Memorandum to the City of Markham Committee of Adjustment

File: A/133/21
Address: 17 Doncrest Drive – Markham, ON (Thornhill)
Applicant: Miguel Maruszki
Agent: David Small Designs (Julie Odanski)
Hearing Date: January 19, 2022

APPENDIX "C"
PLAN OF SURVEY: DECEMBER 15, 2020

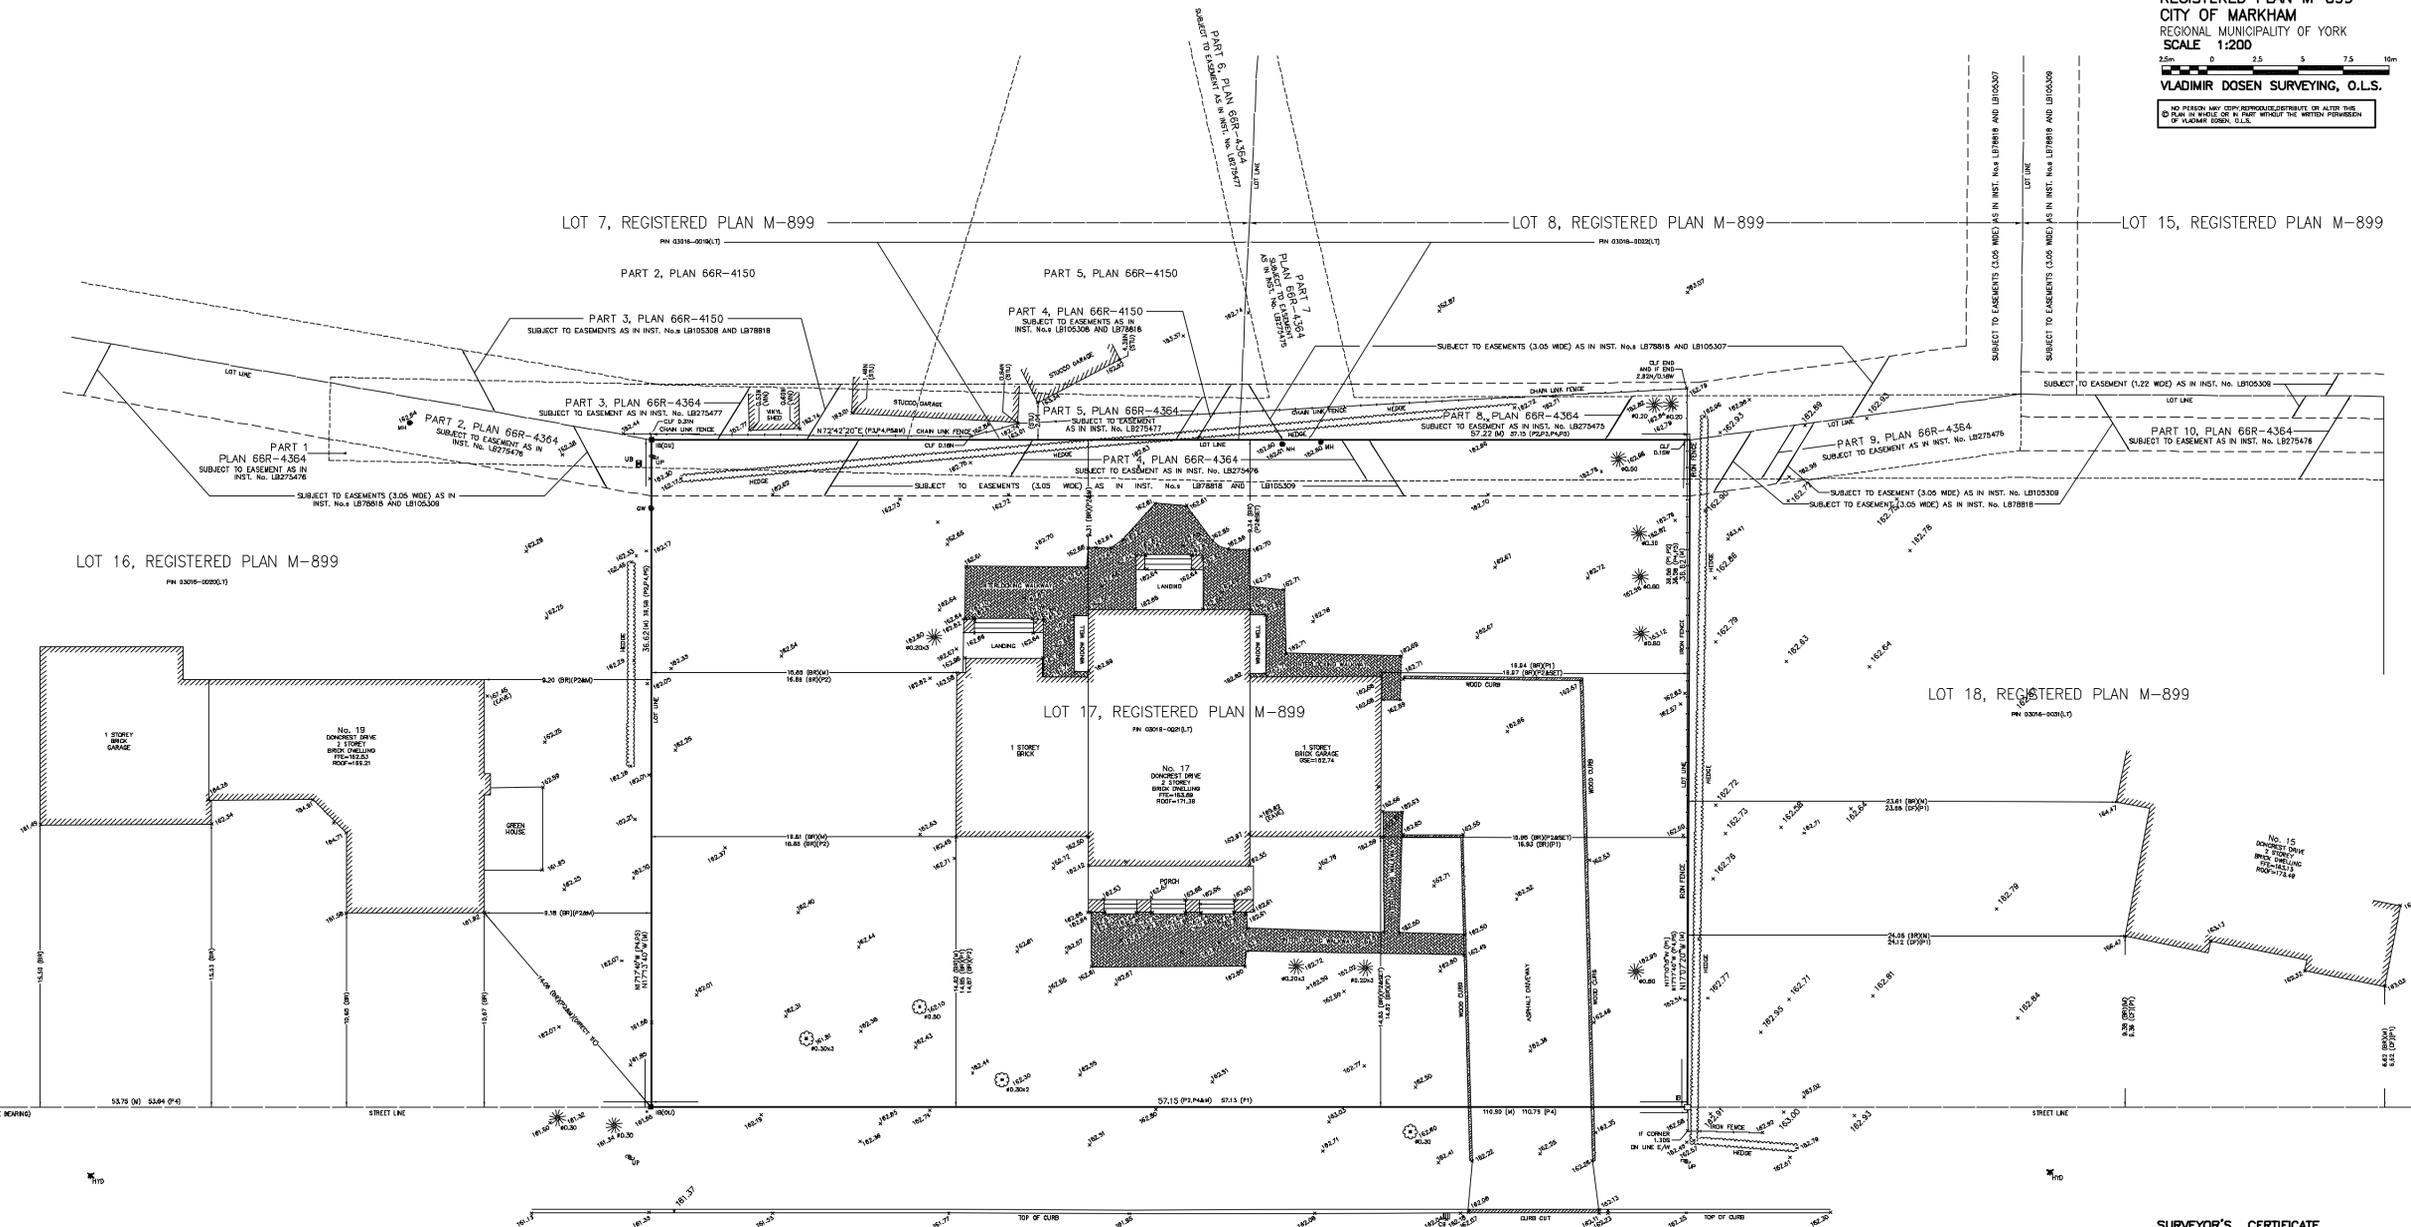
Staff acknowledge that a portion of the rear building wall of the existing two-storey dwelling is setback 9.31 m (30.55 ft) from the rear lot line, as shown in the Plan of Survey submitted by the applicant (Appendix “C”). Staff have also considered the proposed location of the dwelling, and are of the opinion that the rear yard setback would provide for sufficient amenity space in the rear yard and interior side yard (as defined by the by-law). Staff are of the opinion that the requested variance would be of minimal impact to adjacent properties to the north, and that the general intent of the By-law is appropriately maintained.
